Explosion inside an underframe equipment case at Guildford, 7 July 2017

I write to report¹ on the consideration given and action taken in respect of the recommendations addressed to ORR in the above report, published on 20 March 2018.

Recommendation 1

MCM, LCM & ACM module review

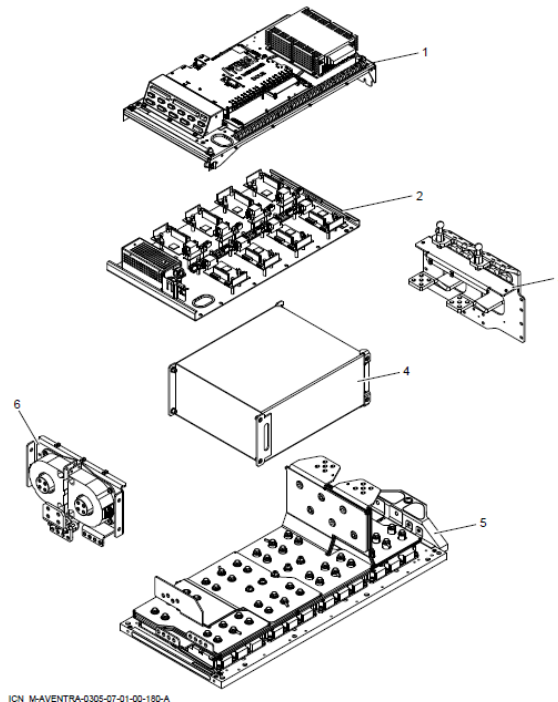
The above diagram identifies 4 as the DC link capacitor in the sealed MCM module. A review of the functional description determines that the capacitor is 'self-healing with segmented metallization using metallized polypropylene' with no contactors within the case.

Mechanical separation and charging contactors are notably installed outside the sealed module.
